SUBJECT: ISSUANCE OF AMENDMENT NO. 33 TO FACILITY OPERATING LICENSE
NPF-38 - WATERFORD STEAM ELECTRIC STATION, UNIT 3
(TAC NO. 66292)

AMENDMENT TO FACILITY OPERATING LICENSE

Amendment No. 33
License No. NPF-38

SAFETY EVALUATION BY THE OFFICE OF NUCLEAR REACTOR REGULATION

Figure 3.1-0

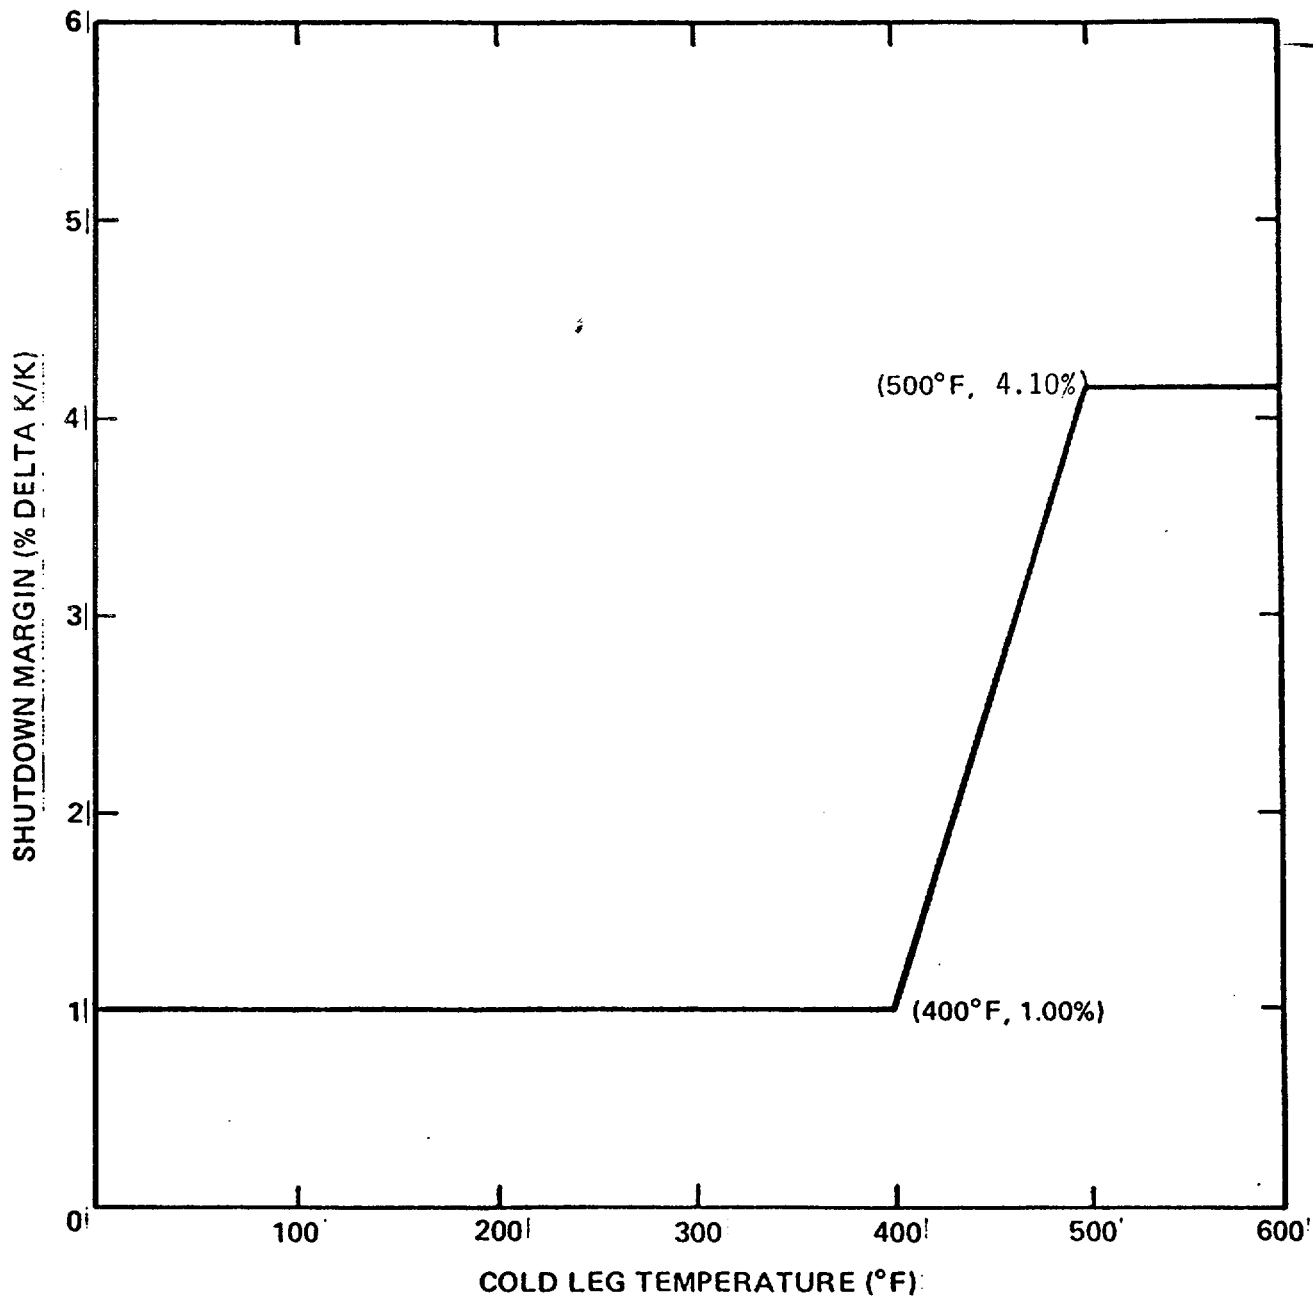
The proposed change would make two additional changes as well. The first is to revise the required value of the Shutdown Margin in Figure 3.1-0 (LCO 3.1.1.2) from 4.15% to 4.10% when T-cold is greater than 500°F. This change reflects the actual value of Shutdown Margin that was assumed in the Cycle 2 Safety Analysis. The licensee's reload analysis was found acceptable in the Safety Evaluation transmittal by NRC letter dated January 16, 1987.

In addition, changing the required shutdown margin when all full-length CEAs are inserted and the Reactor Coolant Temperature (T-cold) is greater than 500°F from 4.15% to 4.10% is being done to make the Technical Specification Shutdown Margin requirement consistent with the licensee's Cycle 2 safety analysis. That is, for those safety analysis events that are affected by Shutdown Margin with all CEAs inserted, a Shutdown Margin of 4.10% was assumed. Since the proposed change is consistent with the safety analysis and since the results of the safety analysis have been shown to be acceptable for all events, the proposed change will have no effect on the capability of the plant safety systems to maintain the reactor in a subcritical condition following any design basis event or anticipated operational occurrence.

3.1.1.2 The SHUTDOWN MARGIN shall be greater than or equal to that shown in Figure 3.1-0.
